Access Compliance Report

Public Rights-of-Way

Intersection ID: N/A	Main Street: PAUL_BUCK_BV	Cross Street: N/A	Location: E
ADA ID: 91BC3A1506FB	Ramp Type: PerpDiag	Initial Pass/Fail: Fail	Overall Compliance: No
			Severity Score: 13.75

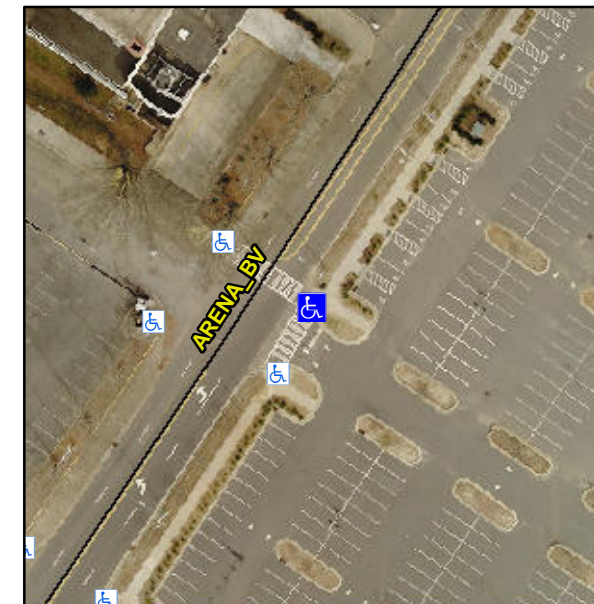
Not Found, R304.2.2, R304.5.3

Compliance	Description	Data	Compliance	Description	Data
N/A	Ramp Length (in)	95.0	No	Ramp Slope (%)	9.0
Yes	Ramp Width (in)	60.0	No	Ramp XSlope (%)	4.5
N/A	Flare Type LT	N/A	N/A	Flare Type RT	N/A
N/A	Flare Slope LT (%)	N/A	N/A	Flare Slope RT (%)	N/A
N/A	Flare Traversable LT?	N/A	N/A	Flare Traversable RT?	N/A
N/A	Landing Length (in)	N/A	N/A	DWS Provided?	N/A
N/A	Landing Width (in)	N/A	N/A	DWS Contrast?	N/A
N/A	Landing Slope (%)	N/A	N/A	DWS Length (in)	N/A
N/A	Landing X Slope (%)	N/A	N/A	DWS Full Width?	N/A
N/A	Landing Curb? (Y/N)	N/A	N/A	DWS Offset (in)	N/A
N/A	Shared Landing?	N/A			
N/A	Gutter Ponding?	N/A	N/A	Gutter Slope (%)	N/A
N/A	Gutter Lip Ht (in)	N/A	N/A	Gutter X Slope (%)	N/A
N/A	Painted X Walk1?	Yes	N/A	Painted X Walk2?	Yes
	X Walk 1 Direction	To NW		X Walk 2 Direction	To SW
N/A	X Walk 1 Width (in)	112.0	N/A	X Walk 2 Width (in)	111.0
	X Walk 1 Slope (%)	1.6		X Walk 2 Slope (%)	4.5
	X Walk 1 X Slope (%)	3.2		X Walk 2 X Slope (%)	1.1

Remove & Replace Curb Ramp With Two New Directional Ramps or Equivalent.
